## TECHNICAL SERVICE BULLETIN

### Coin Chute Modification

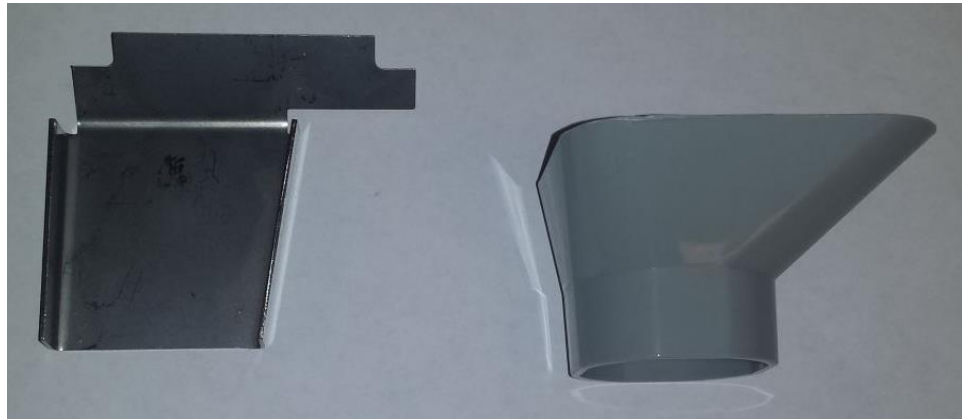
To improve the flow of coins from the coin mechanism into the cash box a modified coin ramp and coin chute are now available. Instructions for installation of the modified coin ramp and coin chute are provided below.

1. Loosen the two bottom coin mechanism mounting nuts.
2. Lift the bottom of the coin mechanism to provide space for the coin ramp (HDM0178800).
3. Slide the coin ramp under the coin mechanism as shown.
4. Tighten the coin mechanism mounting nuts previously loosened in Step #1.

5. Install the modified coin chute (HDM0178900) as usual.
6. Be sure to rotate the coin chute to the proper orientation for each tower.
7. When closing the faceplate be sure to check the coin ramp and modified coin chute for proper alignment.
8. Bend the coin ramp up or down as needed.
